CITY OF ALBUQUERQUE

RE: Garcia Apartments
Grading Plan
Stamp Date: 6/29/17
Hydrology File: K20D063

Based upon the information provided in your submittal received 7/1/17, the Grading Plan **is not** approved for Building Permit. The following comments need to be addressed for approval of the above referenced project:

C1.1

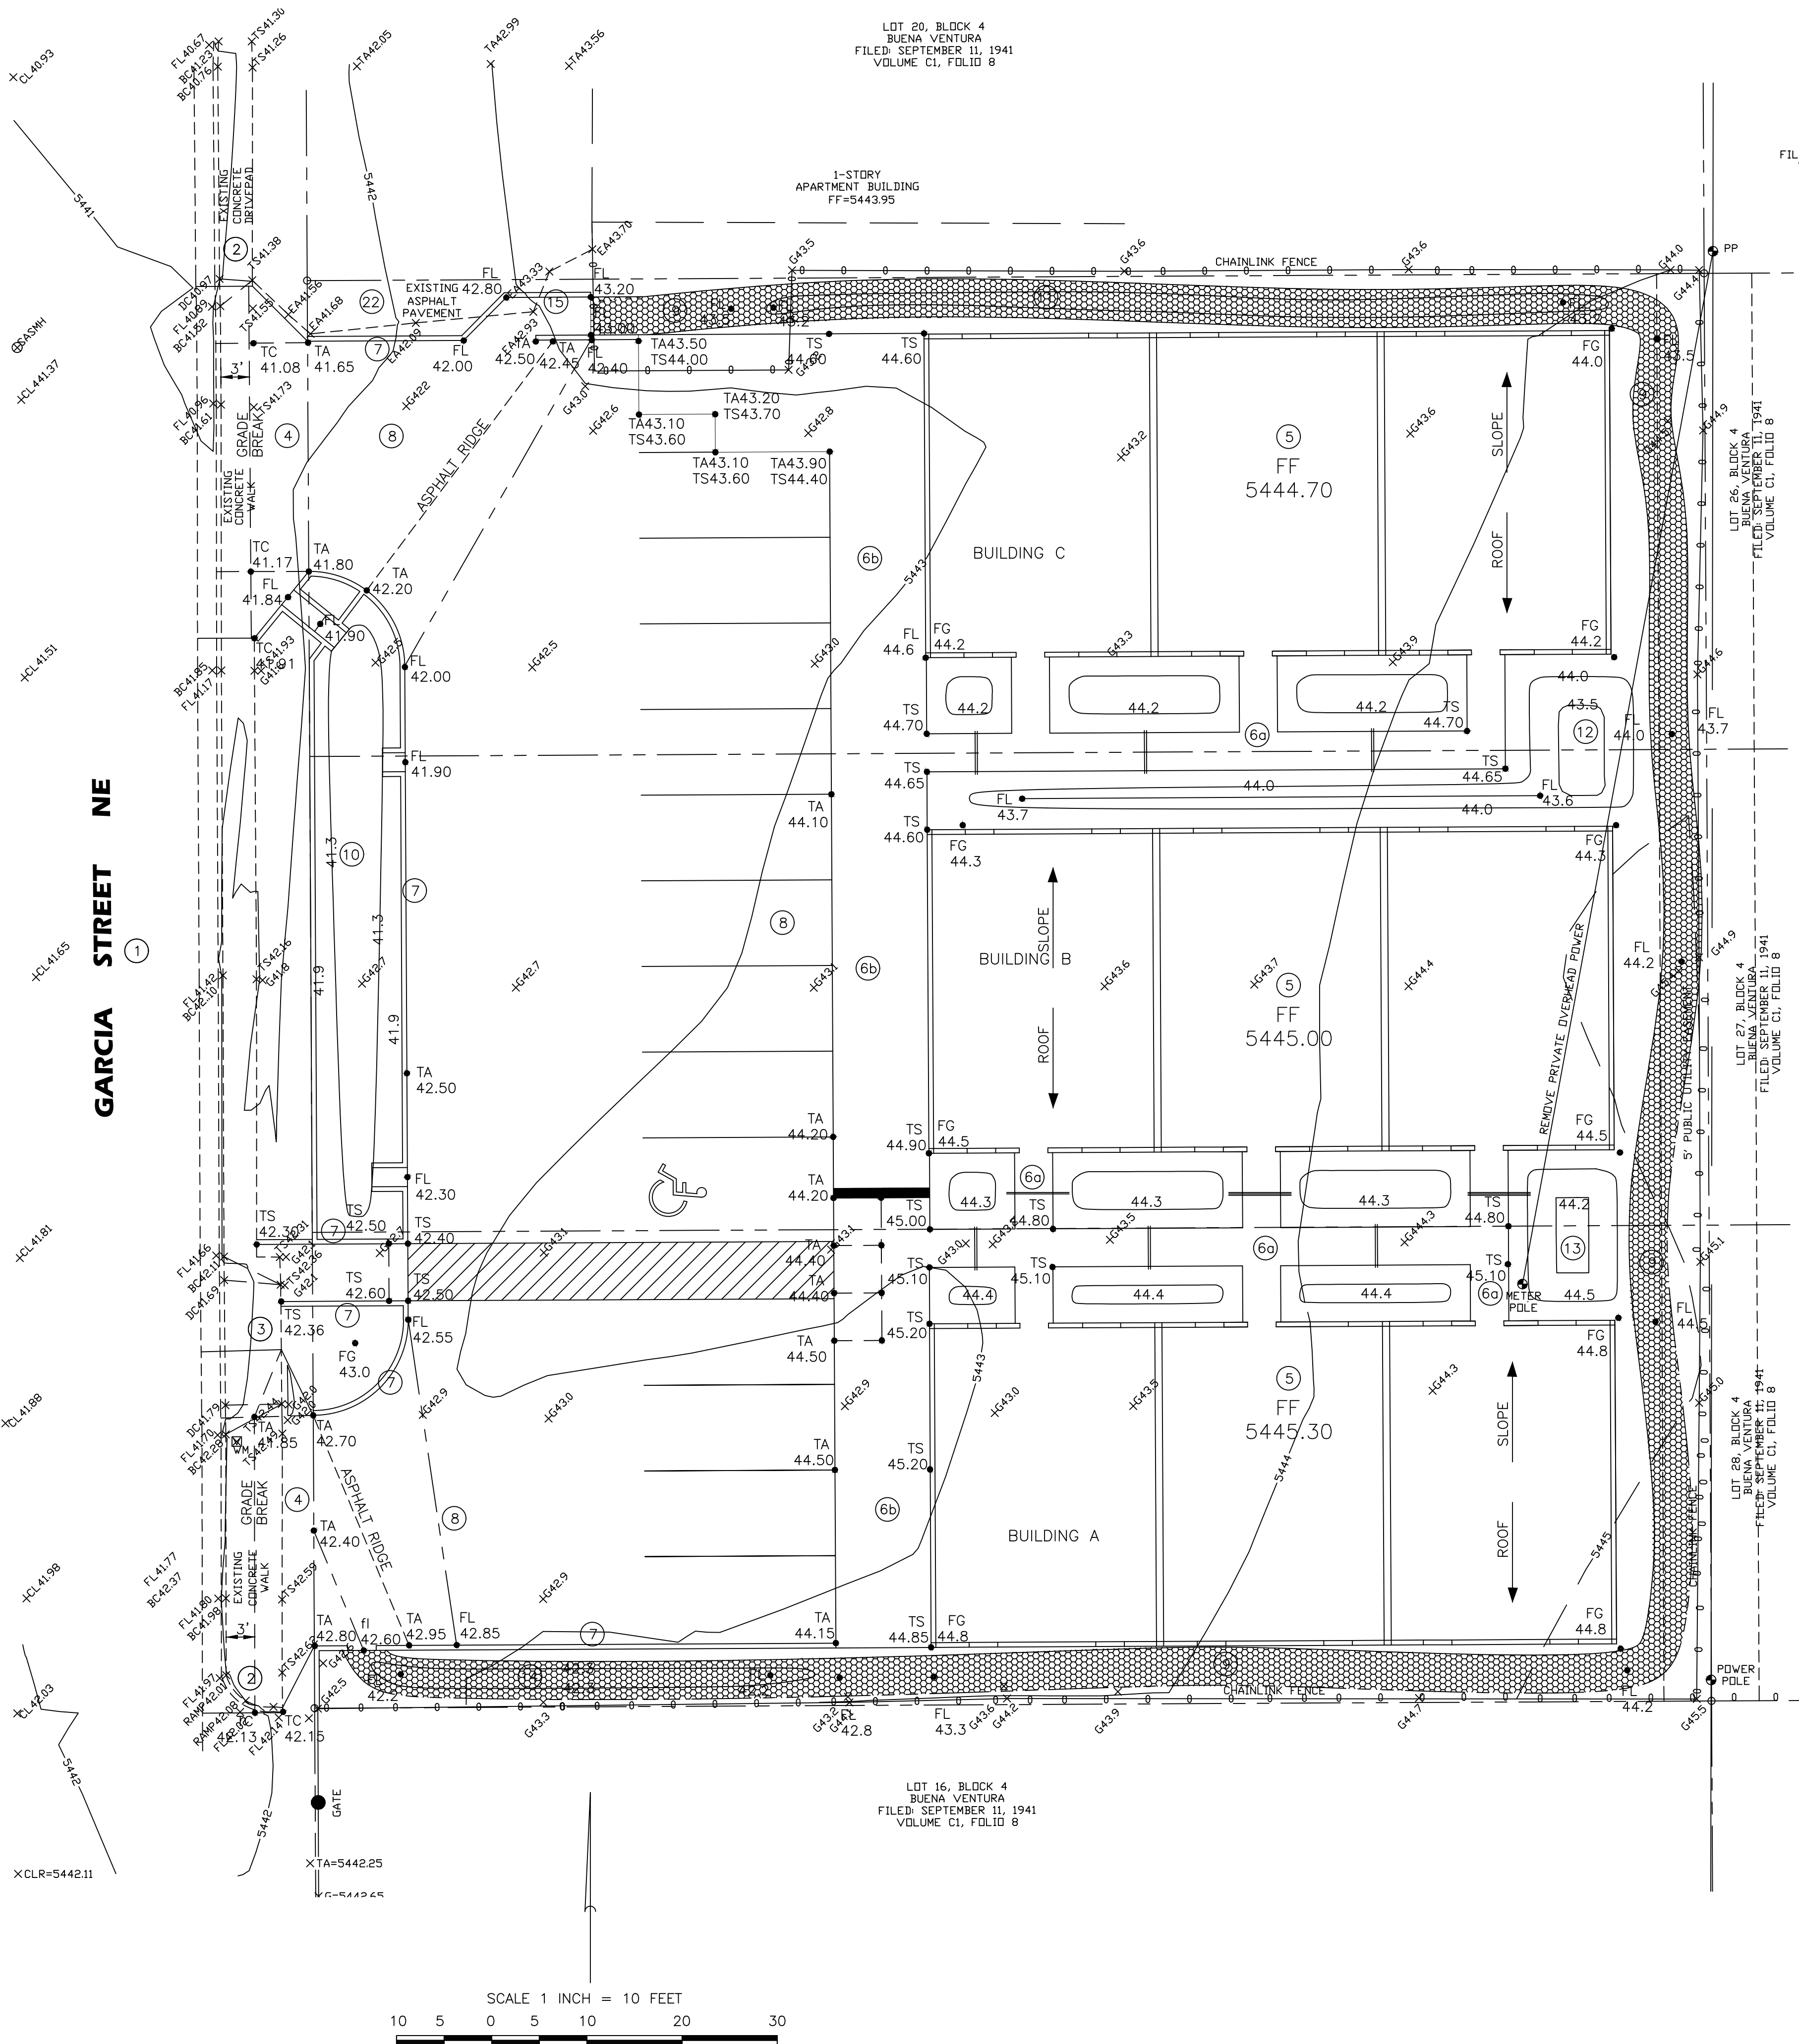
1. On Sheet C1.1. Please turn on the FIRM map.
2. On Sheet C1.11. In Keyed Notes #16 & 17, there is a "X" wide concrete channel" called out. Please the width of these two concrete channels.
3. On Sheet C1-1. Please wipeout the hatch at each Keyed Note's circle so the number can be read.
4. On Sheet C1-2. Please add the proposed volume column in the Water Harvesting chart so the proposed volumes for each pond are shown.
5. On Sheet C1-2. For the Drainage Data, please add drainage arrows. This will help show how the individual basins will leave the site. Also does any of the offsite drainage come onto the site? It is unclear if it does or not, however you do show the offsite area.
6. On Sheet C1-2. Please provide drainage calculations for both the existing and the proposed 100 year – 6 hour storm event.
7. On Sheet C1-2. Please provide the weir calculations for the curb cuts.
